NEBRASKA CAPITOL ENVIRONS COMMISSION

NEBRASKA CAPITOL ENVIRONS COMMISSION STAFF REPORT

APPLICATION NUMBER Urban Design Record #24058
APPLICATION TYPE Certificate of Appropriateness (update)
ADDRESS/LOCATION 225 S 16th Street
HEARING DATE April 26, 2024
ADDITIONAL MEETINGS February 25, 2022, July 28, 2023 and January 26, 2024
APPLICANT Drew Sova, 402-408-0005, dsova@whitelotusgroup.com
STAFF CONTACT Collin Christopher, 402-441-6370, cchristopher@lincoln.ne.gov

Mural Mixed-Use Project Rooftop Screening Review

Proposed Roof Plan - Area A

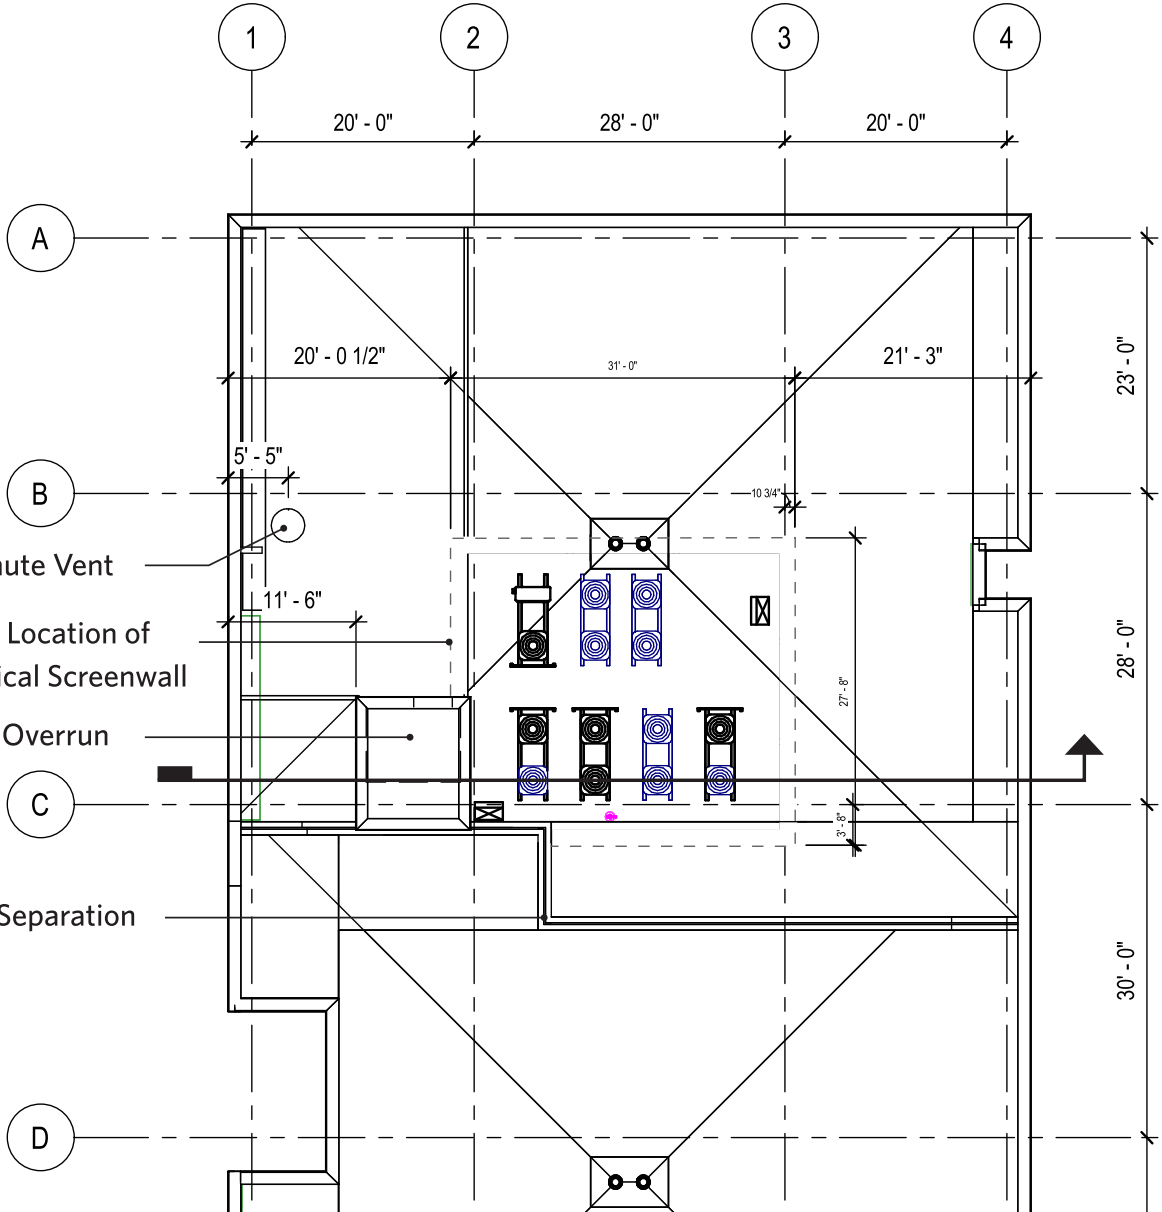
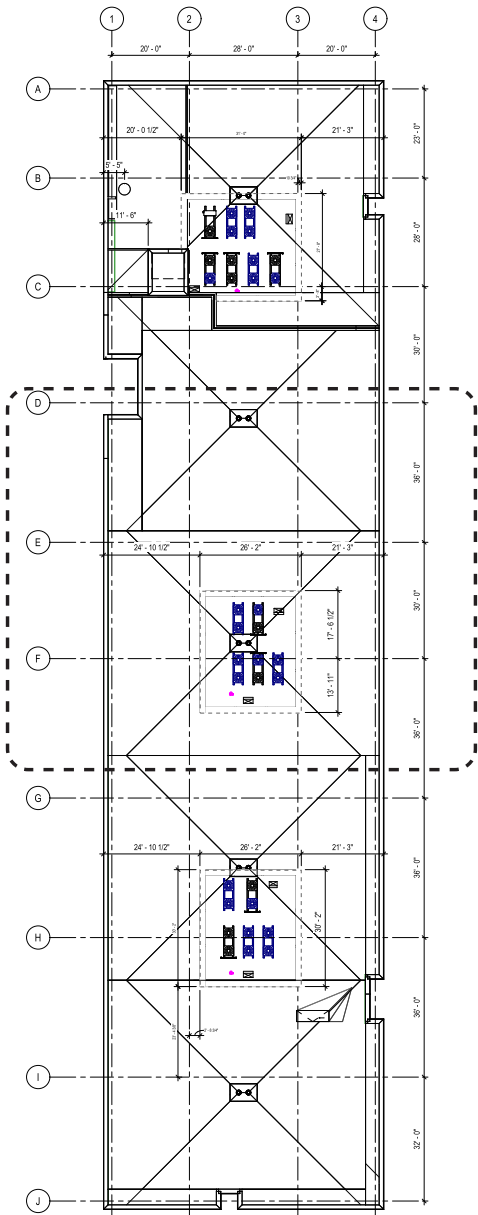
As the applicant moves closer to construction, they are now requesting to remove the previously approved rooftop screening from the project for budgetary reasons. There are no other changes being requested at this time.

Previous Location of Mechanical Screenwall

Recommended finding: The revised submittal that proposes the removal of rooftop equipment screening generally complies with the Capitol Environs Design Standards.

Proposed Roof Plan - Area B

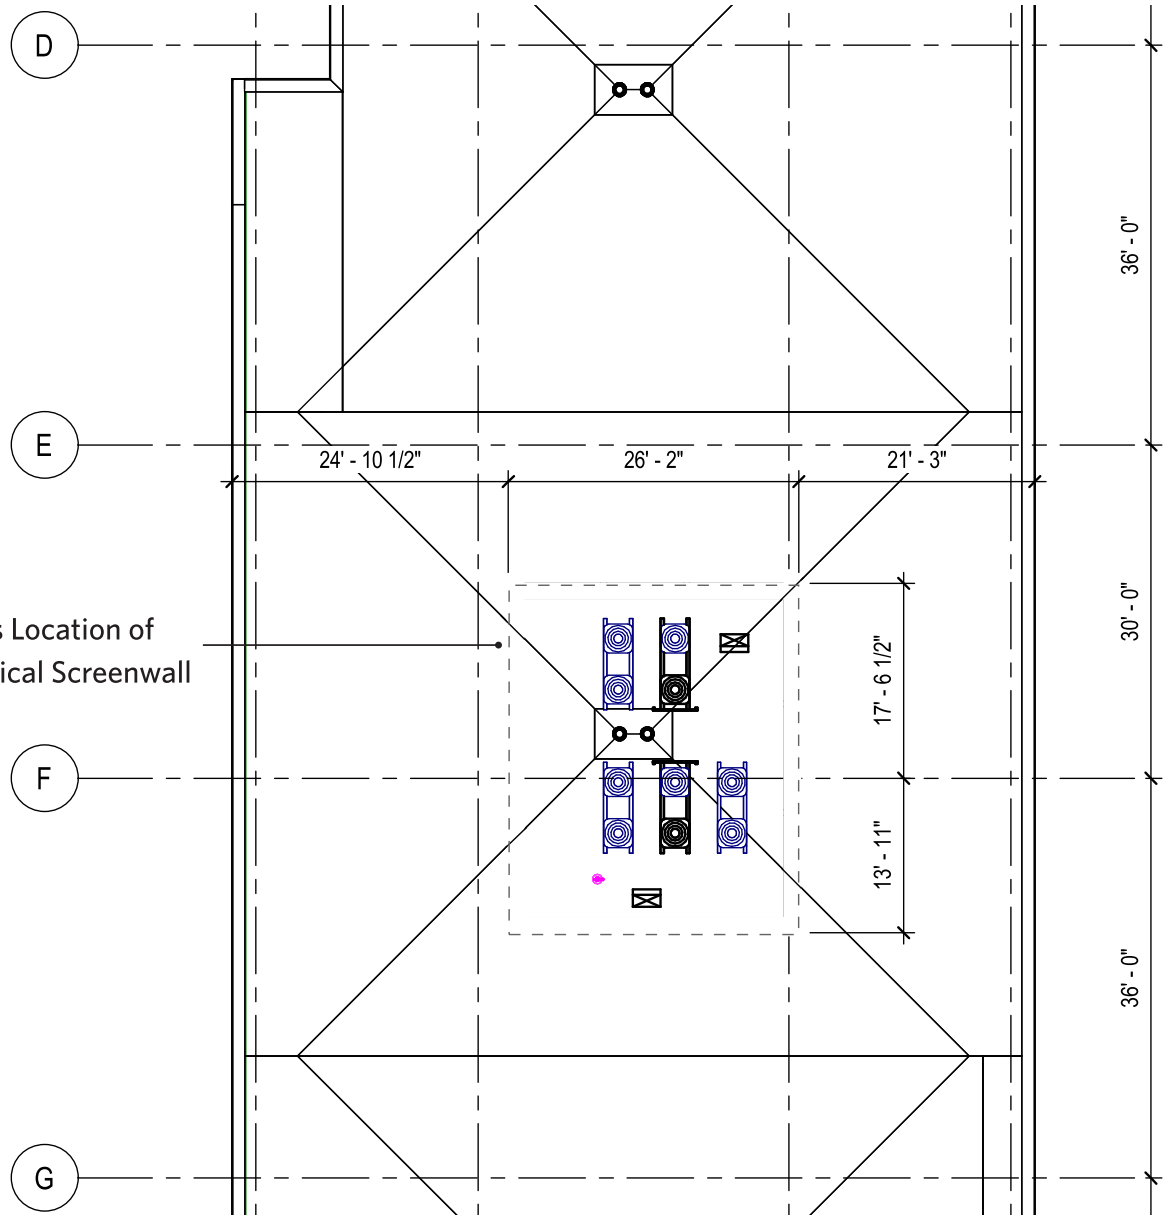
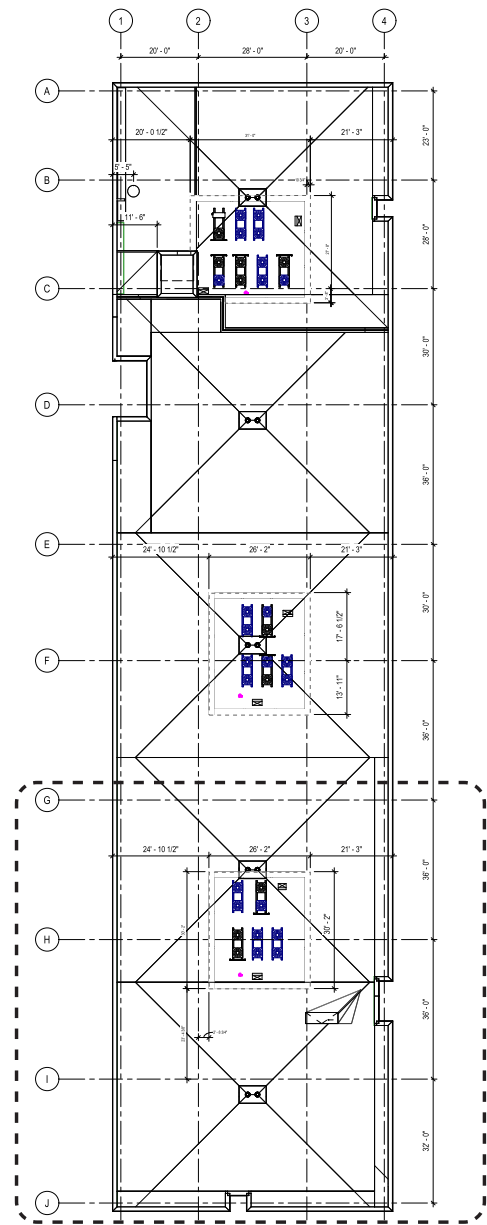
Previous Location of Mechanical Screenwall

Proposed Roof Plan - Area C

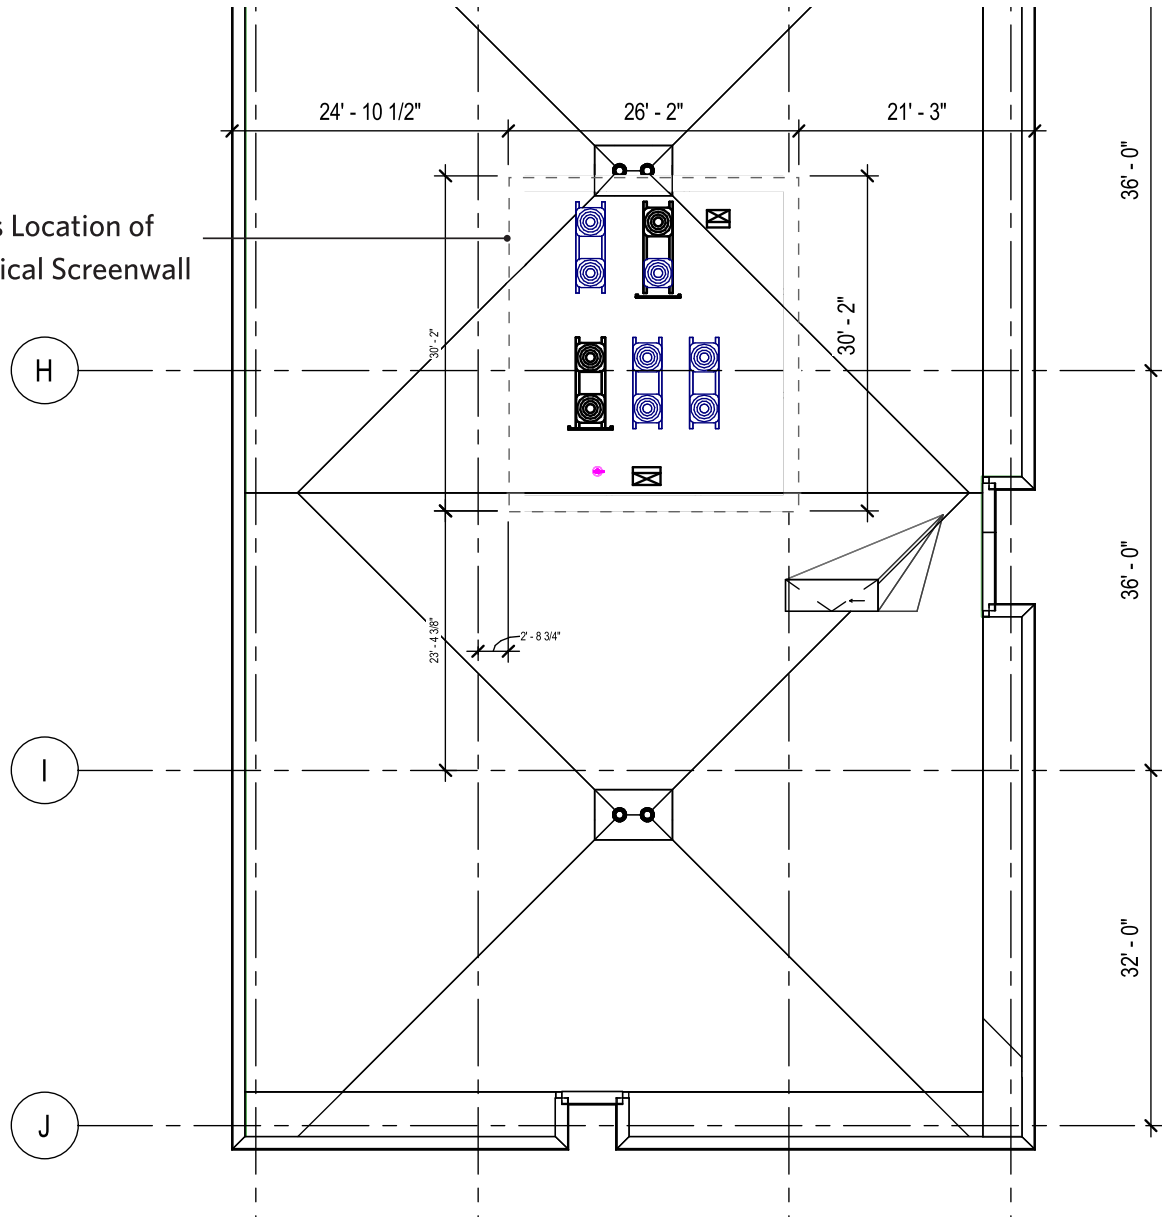
Previous Location of Mechanical Screenwall
